# URBAN DESIGN COMMITTEE

2. [25<sup>th</sup> & Vine Redevelopment](#)  
– [UDR21024](#)

**ITEM 2: 25<sup>th</sup> & Vine Redevelopment**

PROPOSED 36 PLEX APARTMENT COMPLEX

EXTERIOR ELEVATIONS

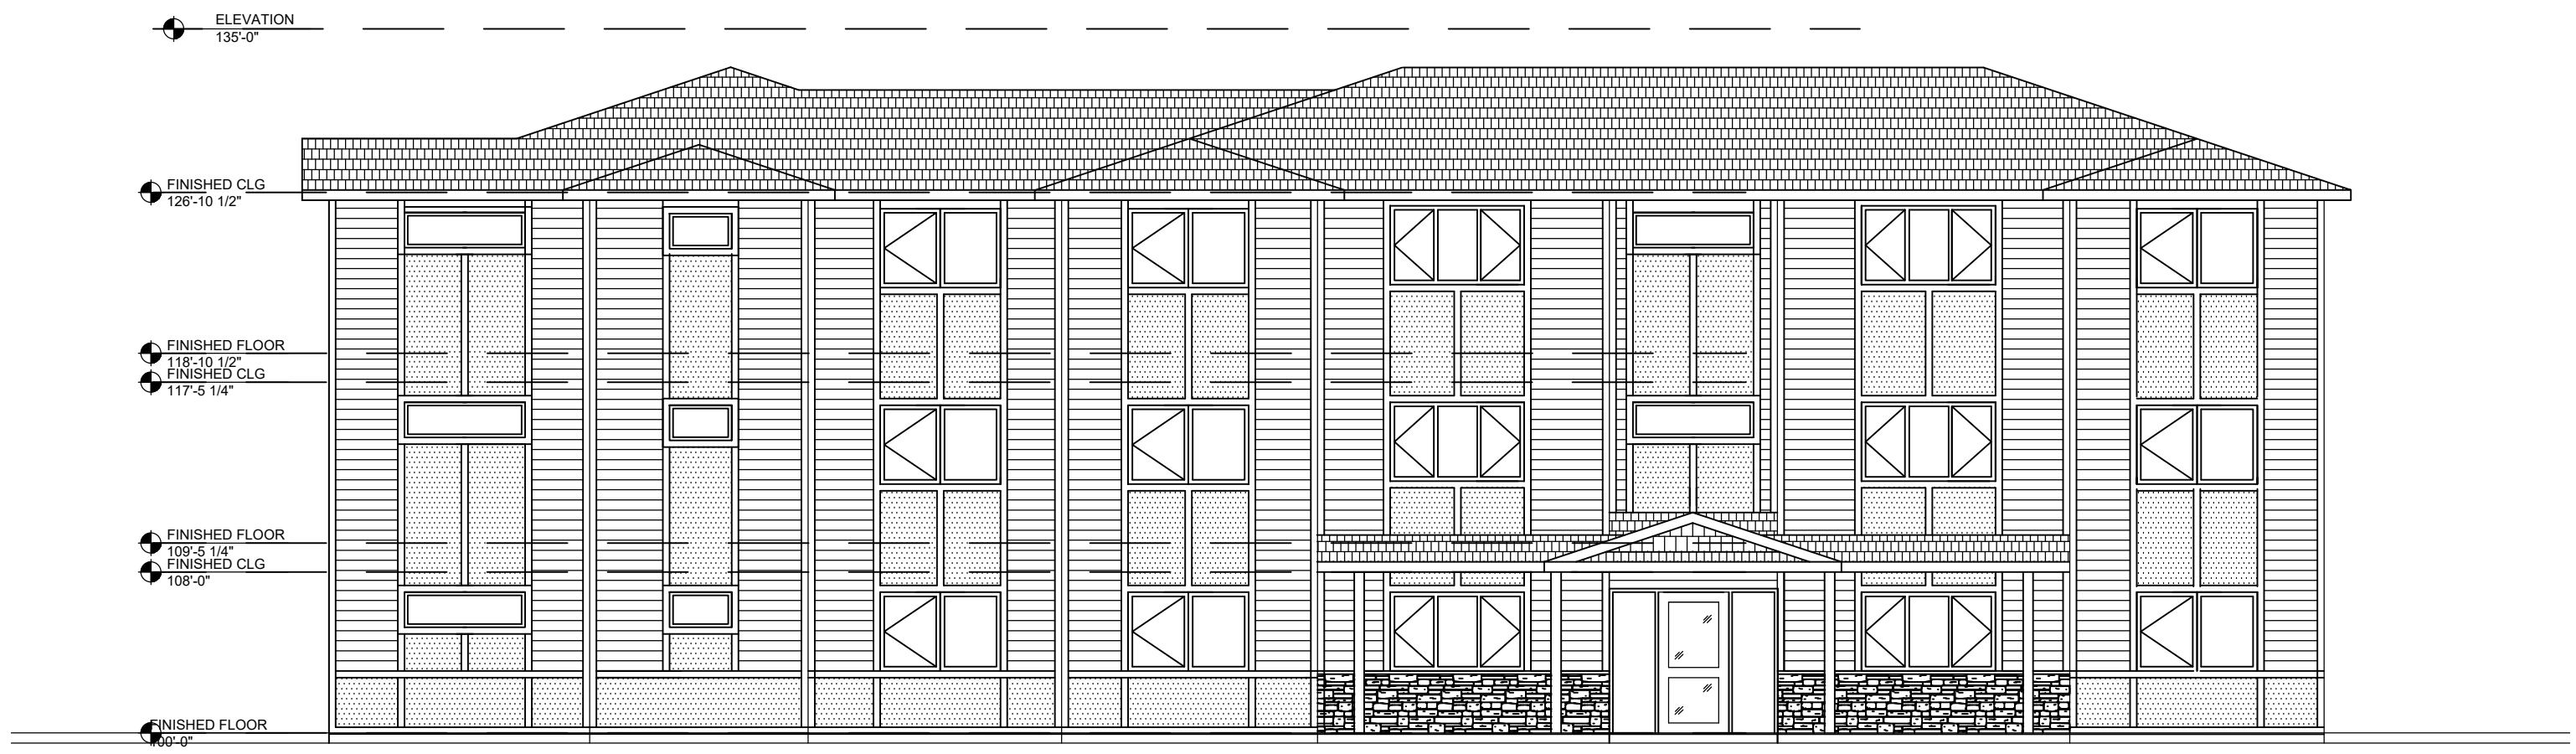
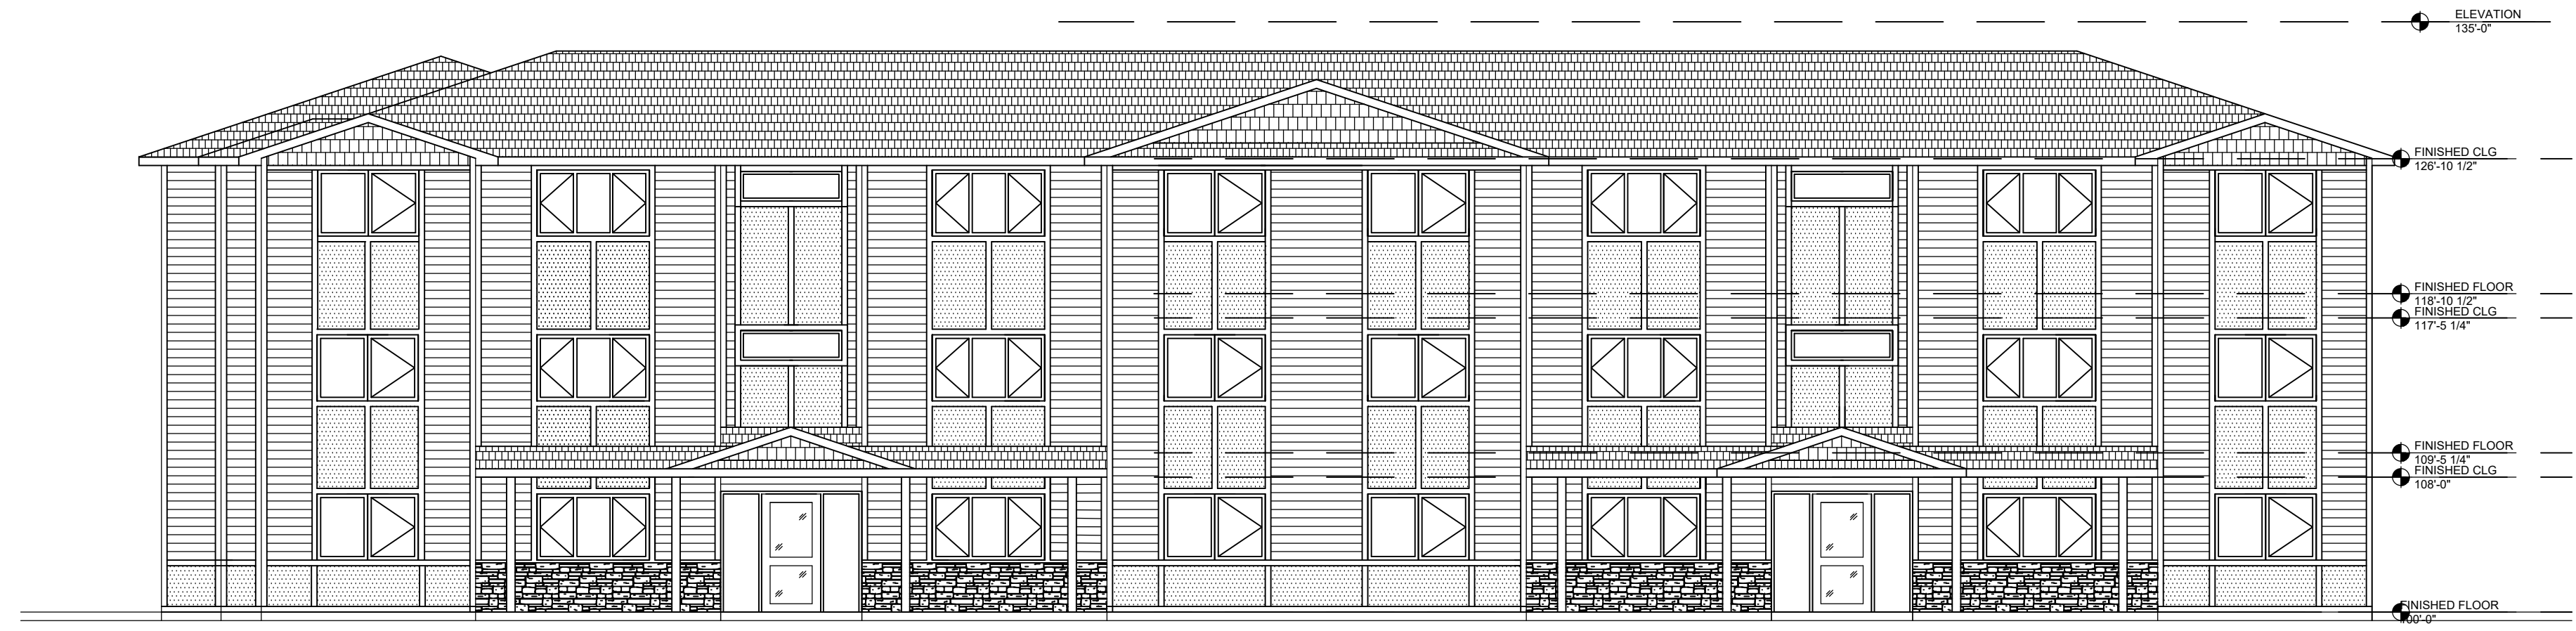
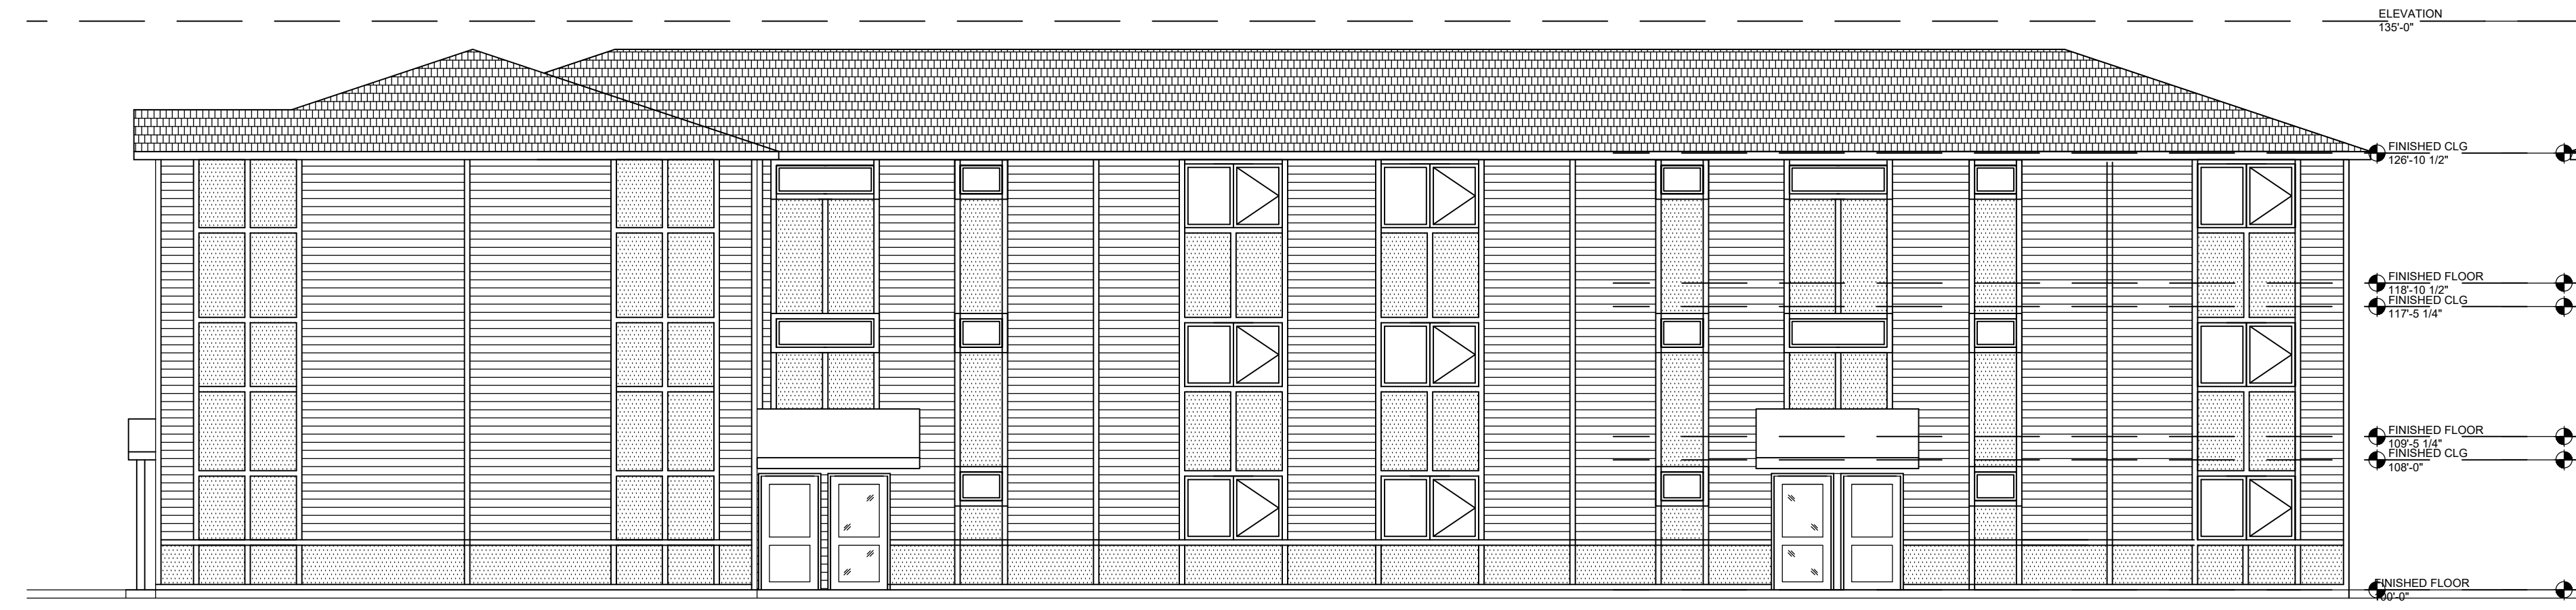
Along with the TIF consideration, one standard warrants your discussion and interpretation. Consider the following Neighborhood Design Standard which addresses long facades along the street:

*The rhythm of similar width houses on similar width lots does much to establish the character of Lincoln’s established residential areas. Large new buildings disrupt this character, unless design measures are employed to reduce their apparent scale. New buildings over fifty feet (50’) in length on the principal street facade should be designed to maintain the rhythm of the existing adjacent buildings. Designs will be bound to meet this standard which offset the principal street facade and roof at intervals of fifty feet (50’) or less. These offsets shall be at least six feet (6’) in depth, and the portions of the facade offset shall equal at least 10% of the length of the facade. Alternate designs that maintain the rhythm of the blockface by such means as shifts in materials within the facade, use of multiple porches and/or dormers, and grouping of windows and entrances, may also be approved on a case-by-case basis.*

The façade is articulated with roof features and offsets in the façade. Methods to further articulate the Vine Street façade should be considered. For example, color could be used to provide variation.
